10-09	LATEST REVISION DATE	 APPROVED BY BRIDGE ENGINEER	 Iowa Department of Transportation Highway Division	
			STANDARD DESIGN - 40' ROADWAY, THREE SPAN BRIDGE PRETENSIONED PRESTRESSED CONCRETE BEAM BRIDGES AUGUST, 2009	
			SUBDRAIN DETAILS	H40-89-06

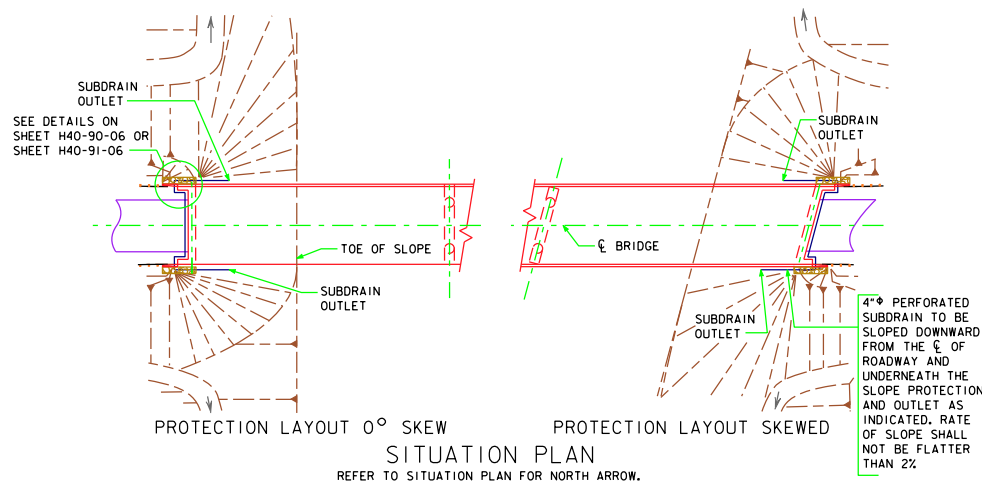
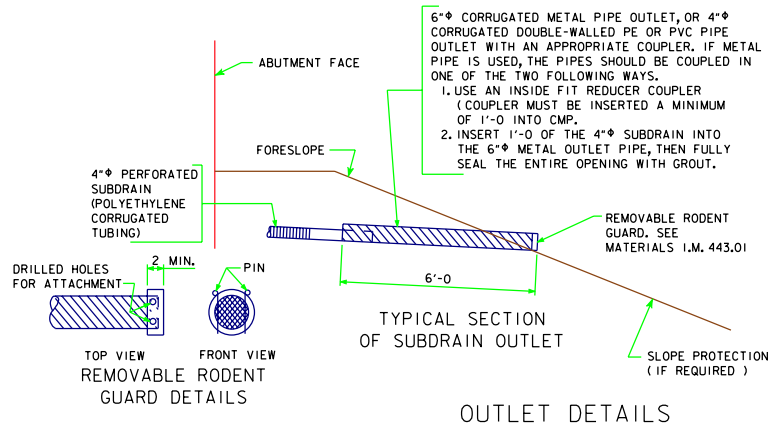
REVISED 10-09 - REMOVED THE GRANULAR BACKFILL DETAIL.
